Safety Evaluation Report

related to the operation of
Perry Nuclear Power Plant,
Units 1 and 2

Docket Nos. 50-440 and 50-441

Supplement No. 10 to the Safety Evaluation Report (NUREG-0887) on the application filed by the Cleveland Electric Illuminating Company on behalf of itself and as agent for the Duquesne Light Company, the Ohio Edison Company, the Pennsylvania Power Company, and the Toledo Edison Company (the Central Area Power Coordination Group or CAPCO), as applicants and owners for a license to operate the Perry Nuclear Power Plant, Units 1 and 2 (Docket Nos. 50-440 and 50-441), has been prepared by the Office of Nuclear Reactor Regulation of the U.S. Nuclear Regulatory Commission. The facility is located in Lake County, Ohio, approximately 35 miles northeast of Cleveland, Ohio. This supplement reports the status of certain issues and action items that had not been resolved or completed at the time of publication of the Safety Evaluation Report and Supplements Nos. 1 through 9 to that report.

Fig. 3.1: Analytical Model of the Perry Reactor Building by CEI (Ref.2)

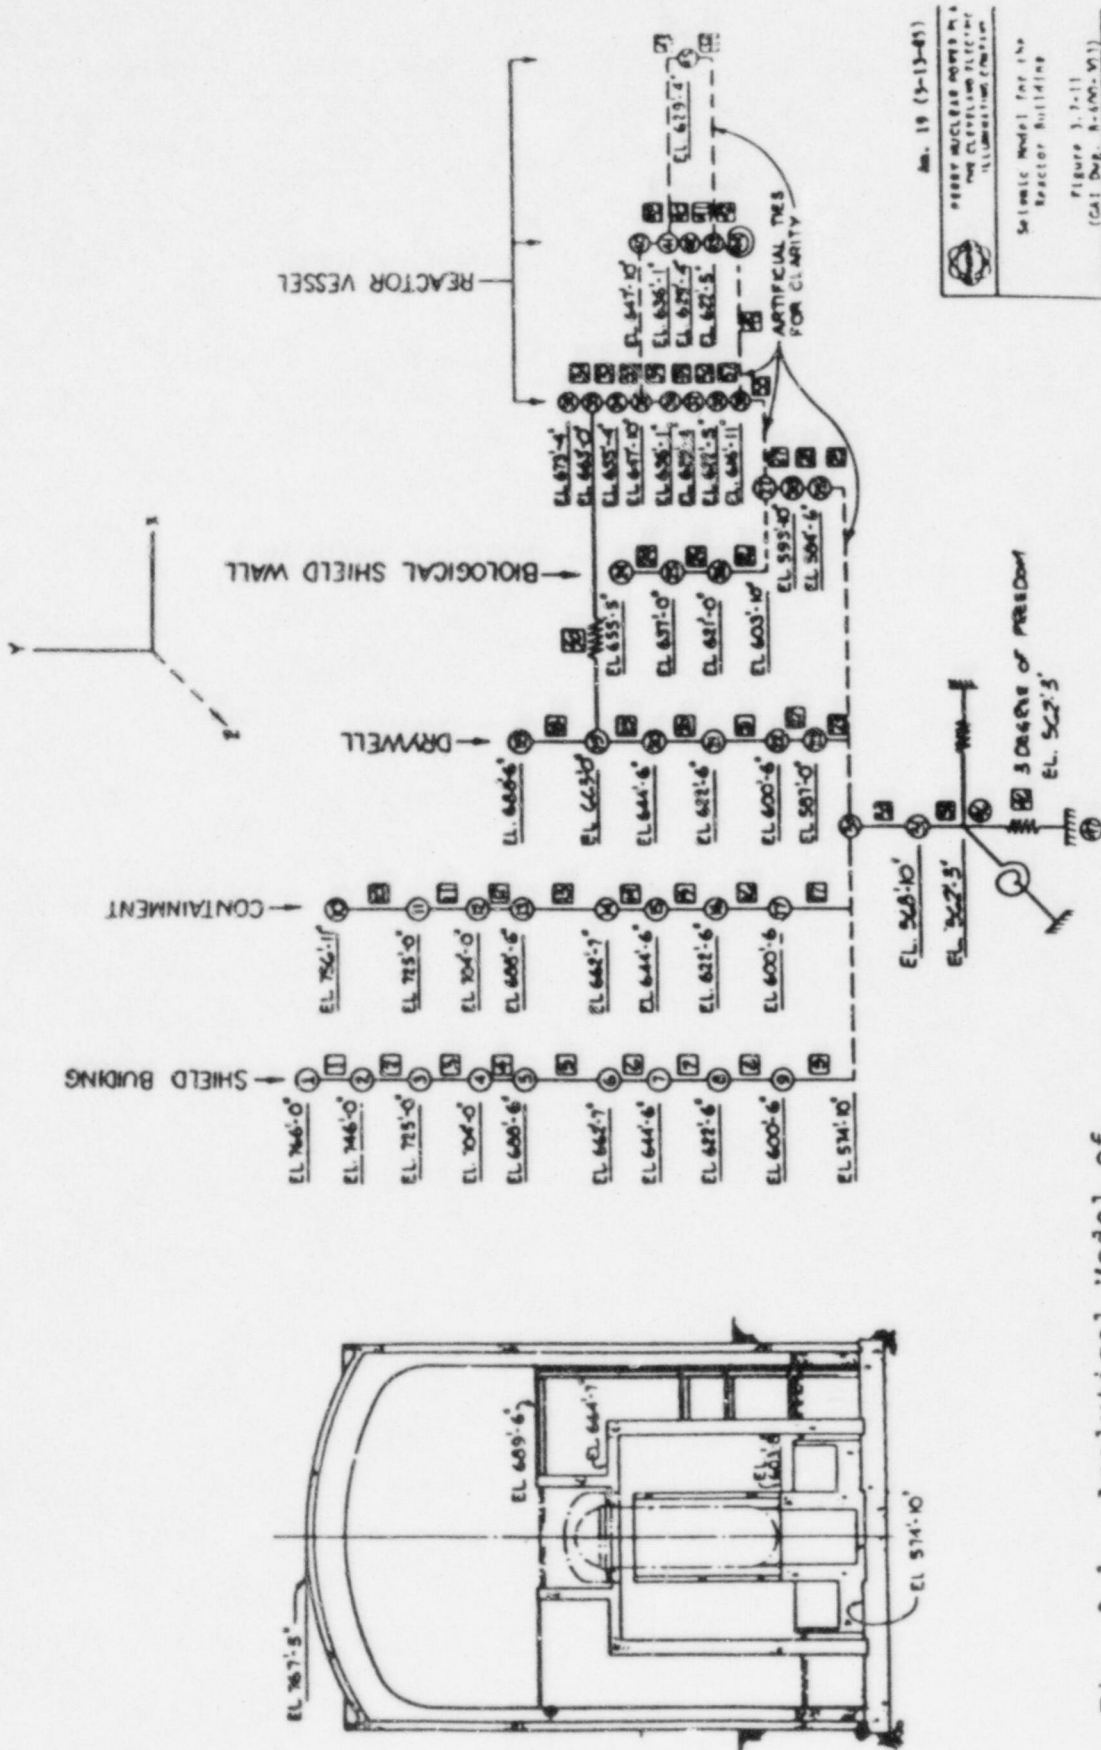
The analyses proceeded by obtaining CEI's reactor building dynamic model (Fig. 3.1) (Ref. 2) and implementing it on the LLNL computer system. During this effort, the structure model was modified in three ways. First, the soil springs located at the base of the model were deleted so that a fixed-base model was obtained. Second, the model of the upper portion of the containment vessel was modified to treat the crane as it was positioned during the earthquake. The mass of node 11 (elev. 725') was reduced and an additional node having the mass of the polar crane was offset 50 ft. south of the containment vessel centerline and rigidly linked to node 11. This modeled the eccentric mass effects of the crane as parked during the event. Dynamically, it couples torsion and east-west translation and increases rotational inertia. Third, a massless node was added at the actual location of the containment vessel instrument and rigidly linked to node 13 which allows one to include the effects of torsion and rocking on the predicted response.

Fig. 3.2: Comparison of Calculated and Measured Response on the Containment Vessel - Vertically Propagating Waves

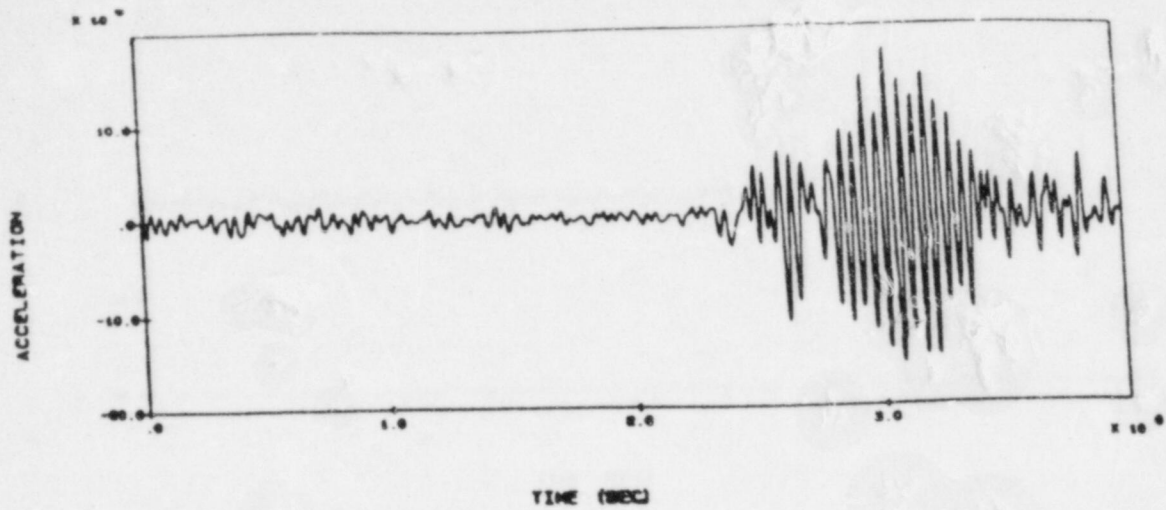
Figure 3.2 compares 2% damped response spectra, calculated and measured, on the containment vessel at elevation 688'. Structural damping was a constant 4% for all modes. Vertically incident waves were the wave propagation mechanism. Structural damping and non-vertically incident waves were the subject of sensitivity studies reported in subsequent sections. The fully modified structural model was used in this analysis.

The response spectra comparison can be separated into three portions: low frequency response (less than 10 Hz), response near 20 Hz, and zero period acceleration (ZPA). For the N-S component, there is no specific low frequency peak. Near 20 Hz and at the ZPA, the responses are under-predicted by 20-30% by the analysis. For the E-W component, the measured response has a low frequency peak at about 4 Hz which is not reproduced in the analysis. The analysis amplifies motion near 7 Hz. Examination of the E-W modes in this frequency range and other sensitivity studies show both peaks to be a function of the input motion. Near 20 Hz and at the ZPA, the calculated responses over-predict the measured values by about 35%. For the vertical component, the low frequency behavior matches well in amplitude and frequency content. Near 20 Hz and at the ZPA, the calculated responses over-predict the amplitudes of response by about 30%.

Fig. 3.6: Calculated Response on the Containment Shell for Different Angles of Incidence

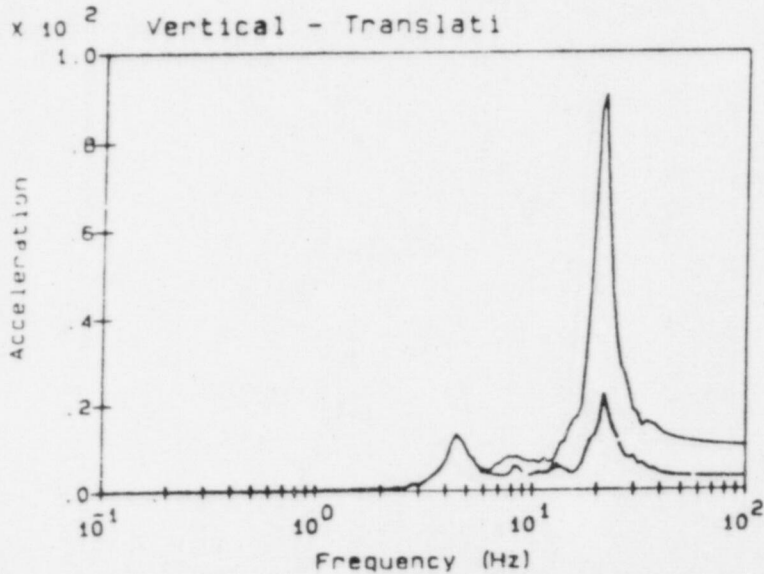
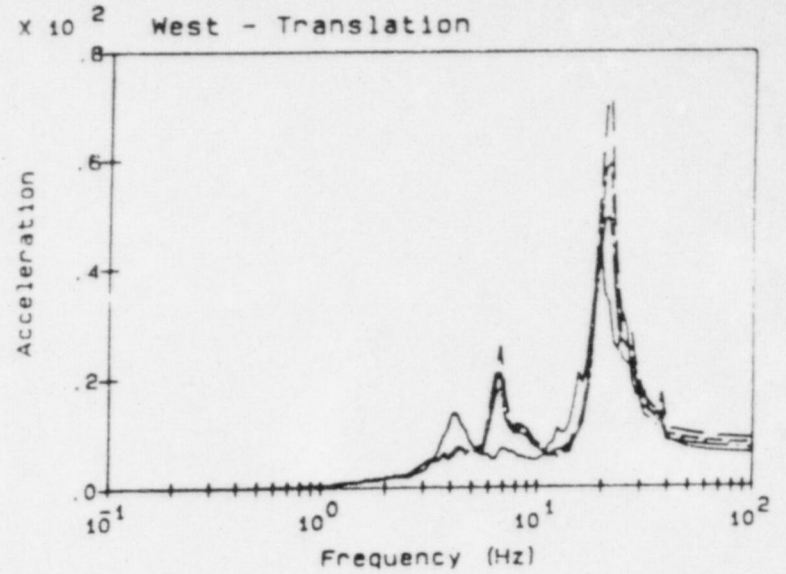
significantly with increasing angle. Figure 3.6 shows the calculated response on the containment vessel at the location of the instrument. For all components the spectral peak near 20 Hz decreases with increasing inclination angle. Response in the N-S direction increases at 4 Hz with increasing angle, but E-W response is unaffected below about 7 Hz. Comparison of these spectra with those of the recorded motions shows little improvement in agreement for non-vertically incident waves. Thus, it does appear that vertically incident waves lead to the best estimate of containment vessel response; especially the near 20 Hz spectral acceleration.

Fig. 3.7 Comparisons of Calculated Response from Fixed-Base Analyses with Recorded Response at El. 686 ft. on Containment Shell

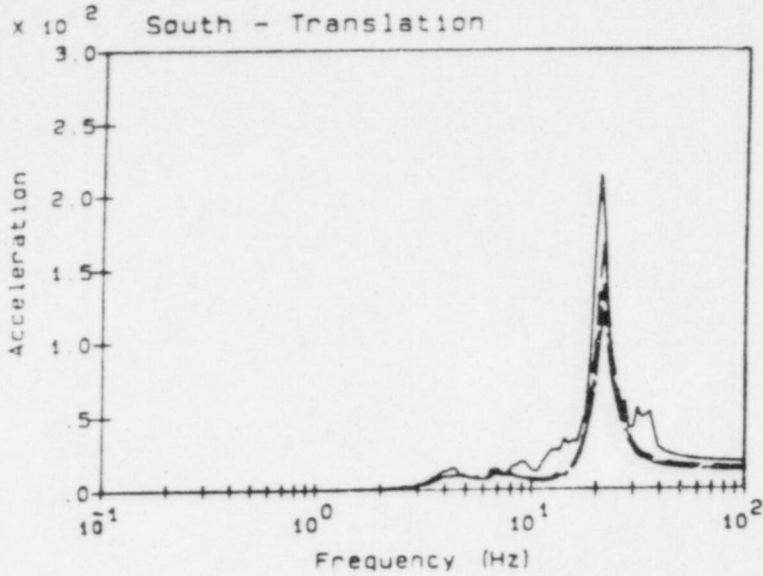
Early in the present investigation, we studied the effect of structural damping on response of the containment vessel. The only structural model modification incorporated in this study was considering a fixed-base structural model. Hence, the responses reported here are on the centerline of the containment vessel and do not include the crane eccentricity or a rigid link to the instrument location on the shell itself. Quantitatively, the effect of damping on response can be observed from Fig. 3.7. Of note, however, is that the 3% damped case does not increase containment vessel response near 20 Hz enough to match recorded motion in the N-S direction. In the E-W direction, the 5% damped case still slightly over-predicts response. Finally, vertical response at the shell centerline is independent of structural damping. Comparing vertical response of Fig. 3.2 and Fig. 3.7 shows the importance of rocking at elevation 688' on the vertical component.

The damping parameter variations investigated here did not produce changes in response large enough to permit predicted response to match calculated response near 20 Hz or at the ZPA.
